Planning Commission Date: May 23, 2007 Item No. 2.

MILPITAS PLANNING COMMISSION AGENDA REPORT

TITLE:	**USE PERMIT NO. UP2007-5 and "S" ZONE APPROVAL NO. SA2007-5**
Proposal:	A request for a new sign program, which includes installation of a new monument sign at the corner of McCarthy Boulevard and Sumac Drive for the SanDisk corporate campus.
Location:	601 McCarthy Boulevard (APN: 086-02-039) and 900 to 1100 Sumac Drive (APN: 086-01-037, 039, 040)
RECOMMENDATION:	**Approval with conditions**
Applicant:	SanDisk Corporation, 601 McCarthy Blvd., Milpitas, CA 95035
Property Owner:	RREEF, 3303 Octavius Drive #102, Santa Clara, CA 95054
Previous Action(s):	"S" Zone approval and amendments
Environmental Info:	Exempt from CEQA pursuant to Section 15311 (Accessory Structures)
General Plan Designation:	Industrial Park
Present Zoning:	Industrial Park with "S" Combing District (MP-S)
Existing Land Use:	R&D Buildings
Agenda Sent To:	Applicant/Owner
Attachments:	Plans
PJ No.	2484

SIGN (C) EXISTING

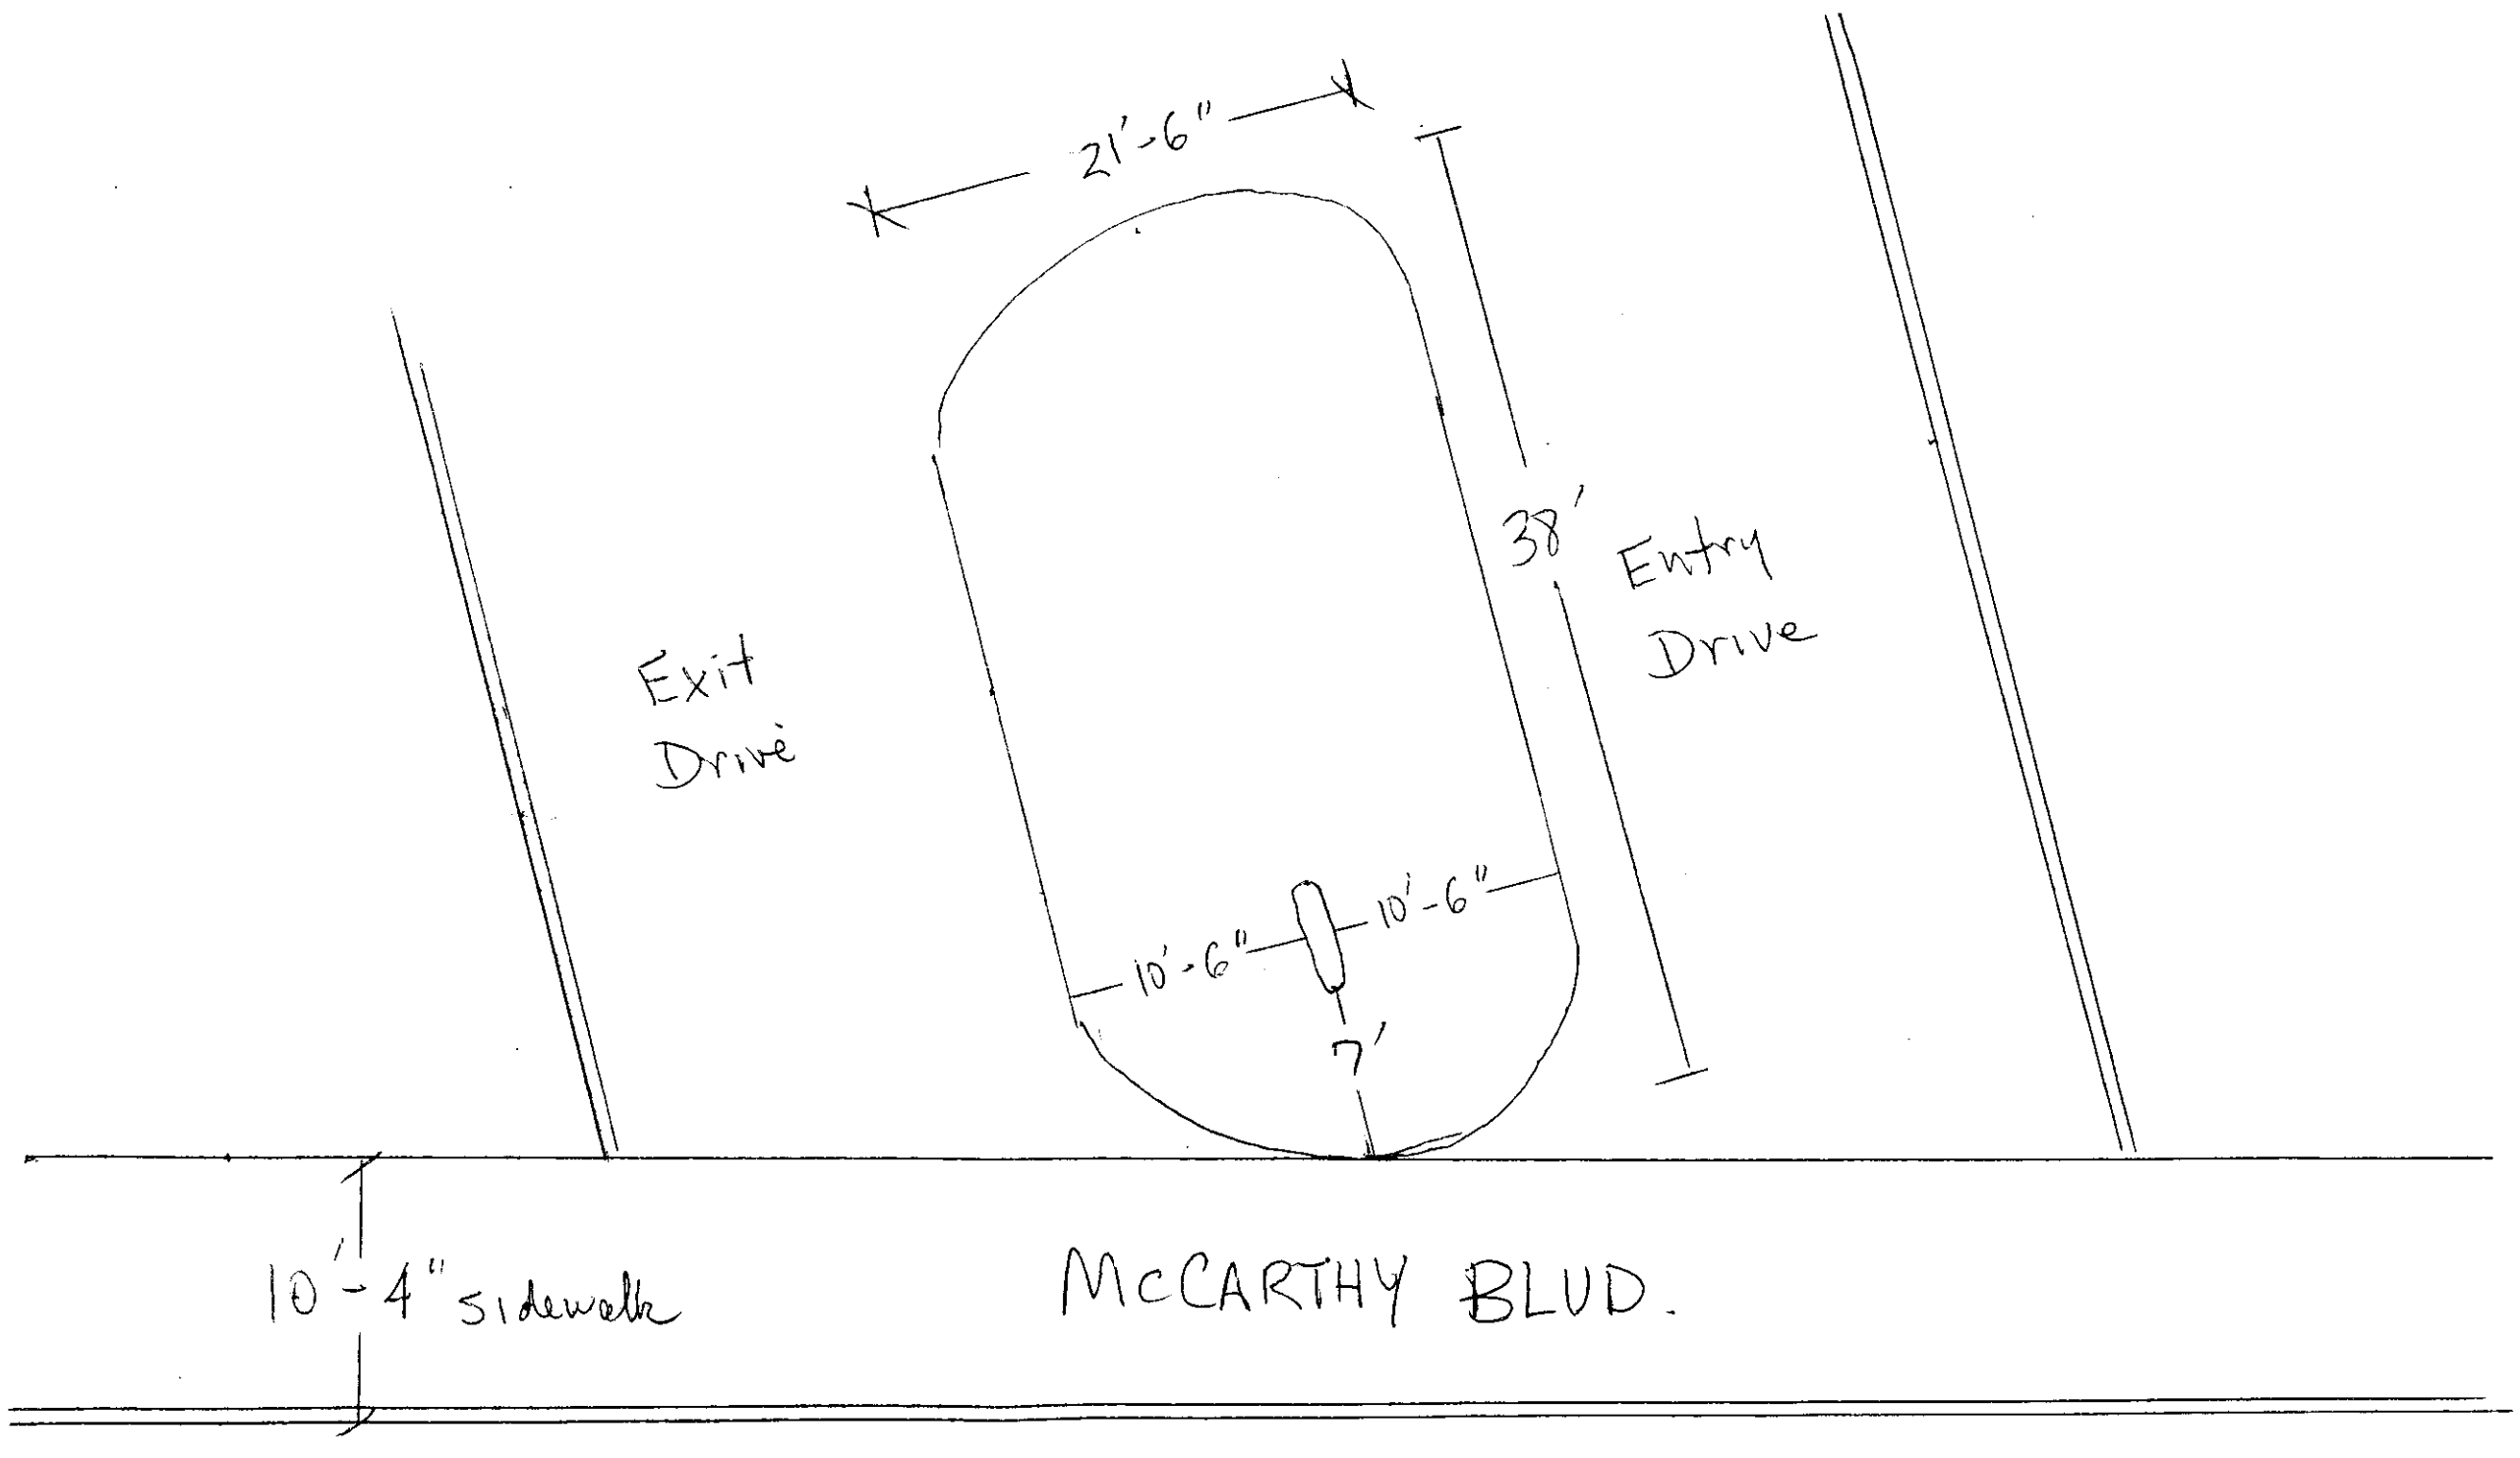
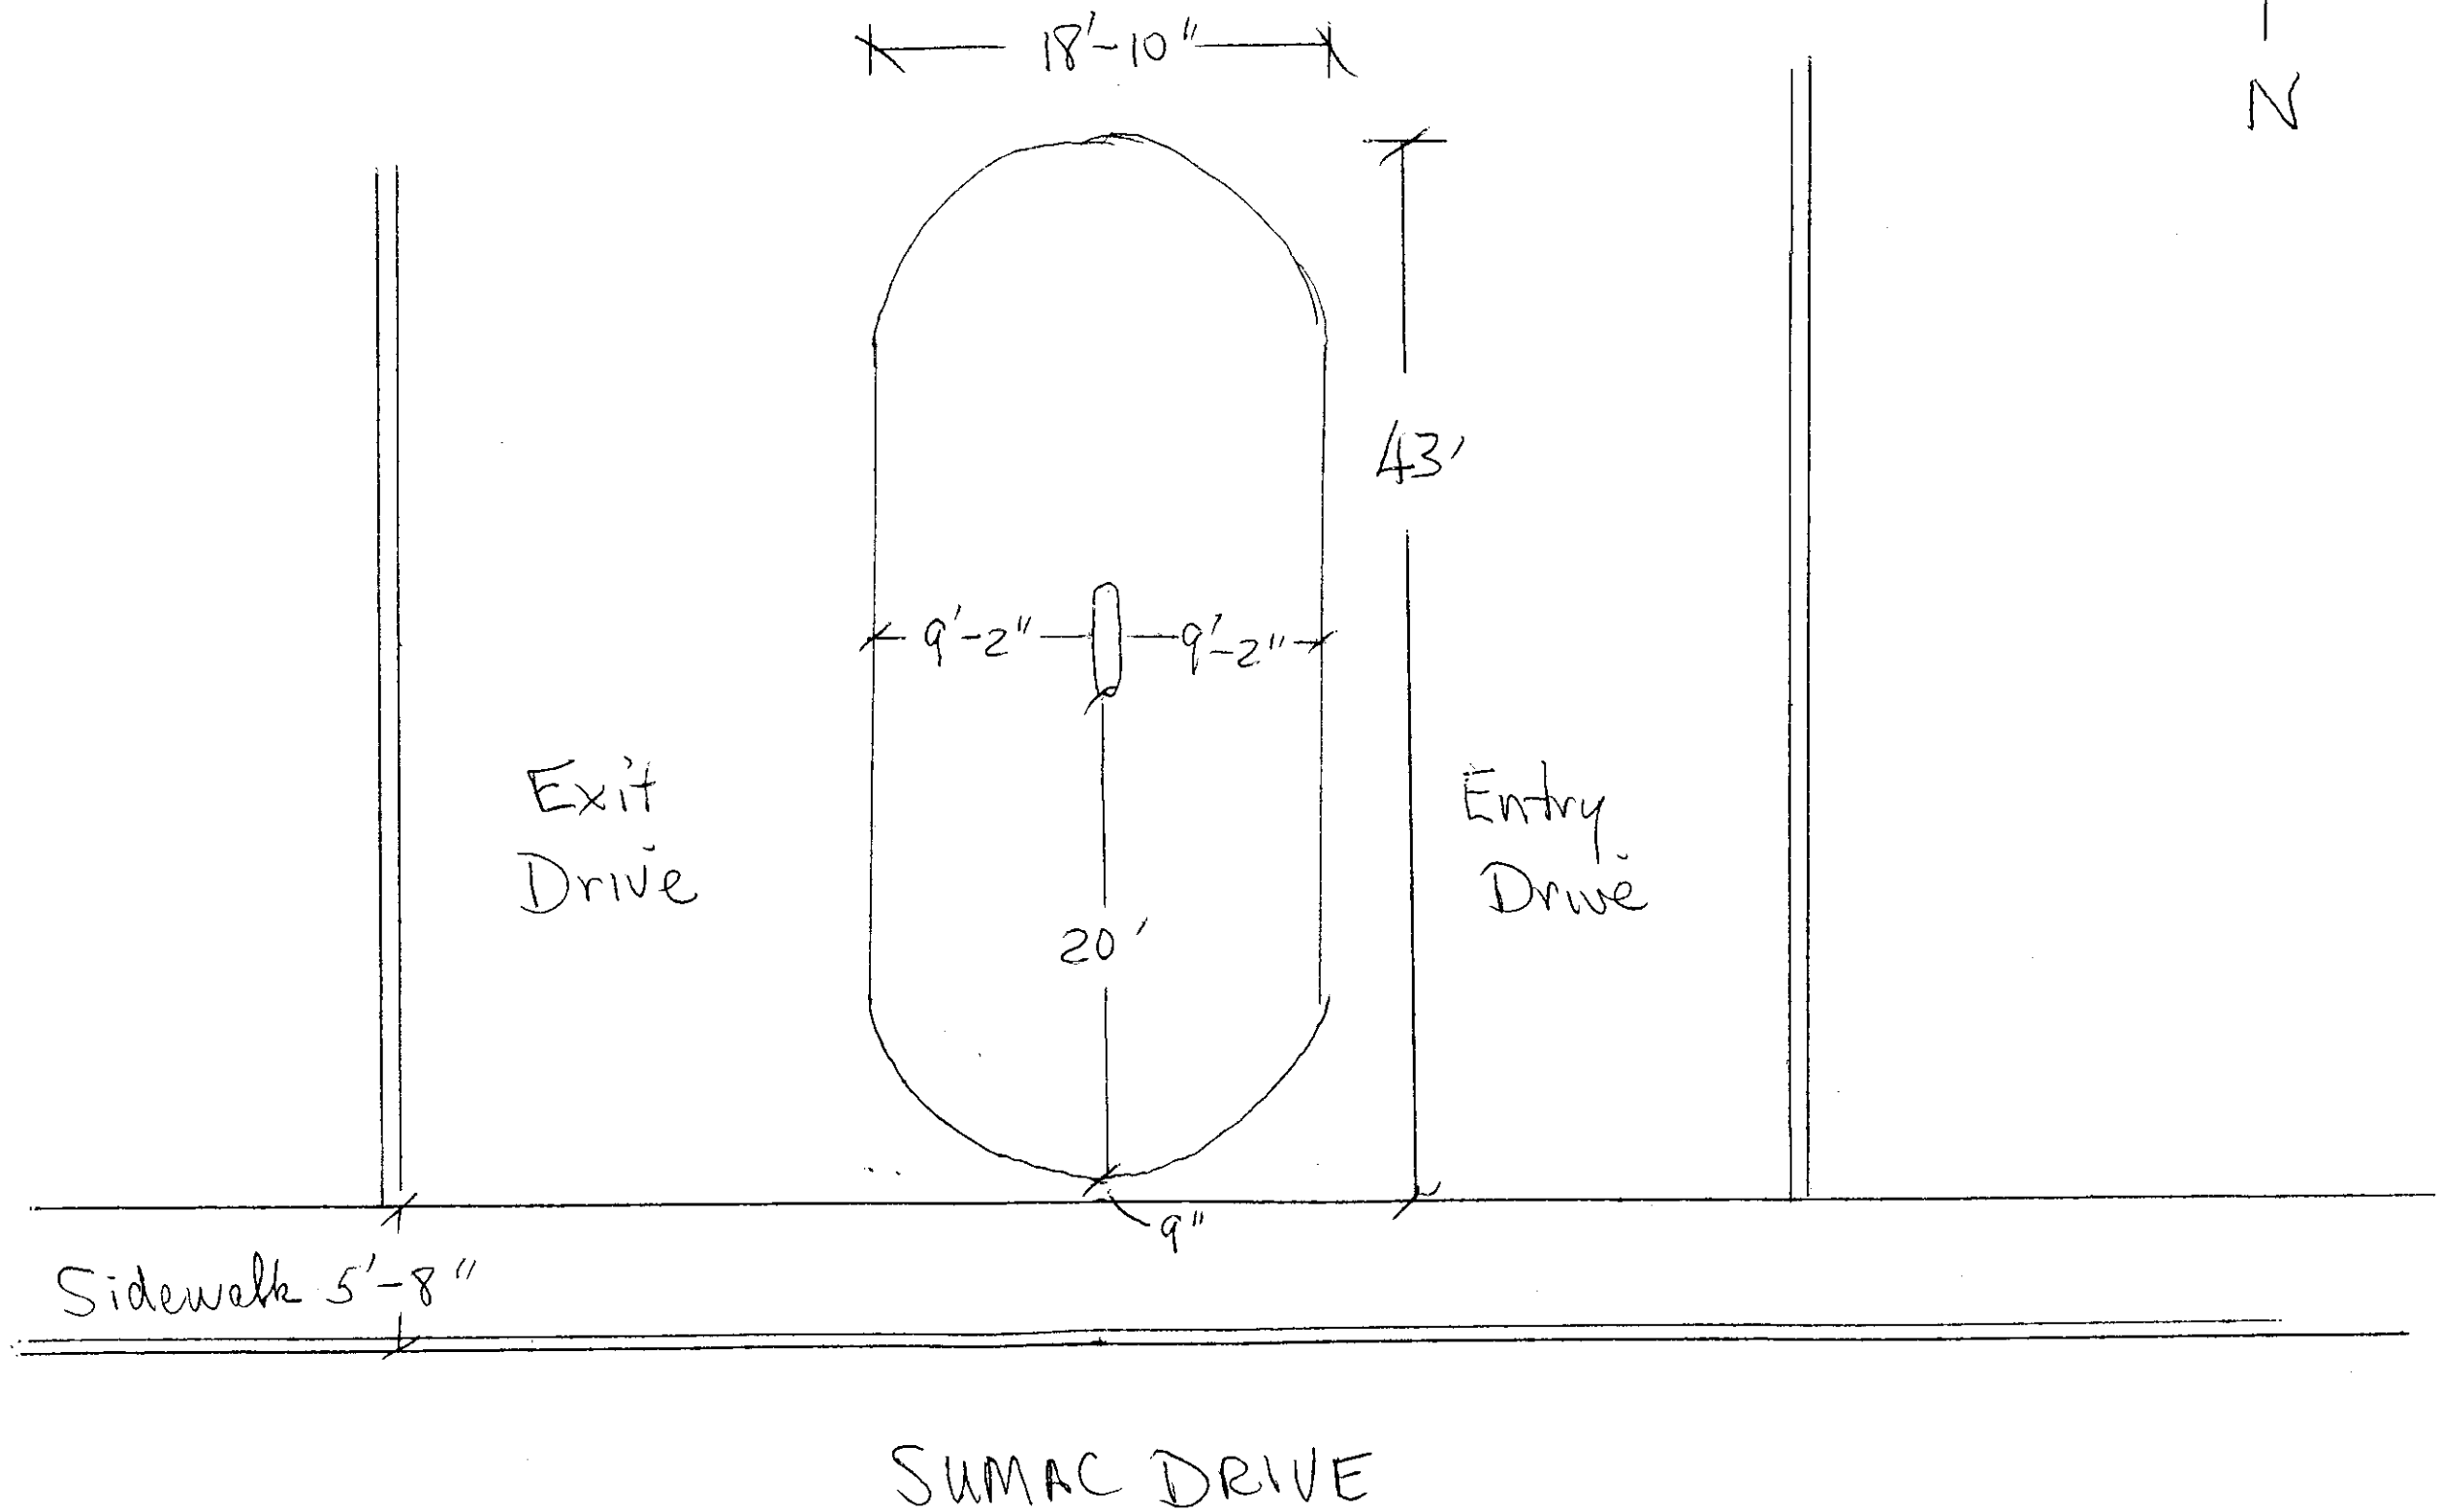
Staff is concerned with the visibility of the lettering on the driveway directional signs. As proposed, the driveway directional signs are located in a landscaped median. During a site visit staff noticed that the address and building numbers were obscured due to the existing height of the shrubs and/or have missing landscaping. *Staff recommends* a condition that the applicant modifies the driveway medians with suitable landscaping that is attractive and enables the lettering on driveway directional signs to be clearly visible and legible

3. The applicant shall modify the driveway medians with suitable landscaping that is attractive and enables the lettering on driveway directional signs to be clearly visible and legible. (P)
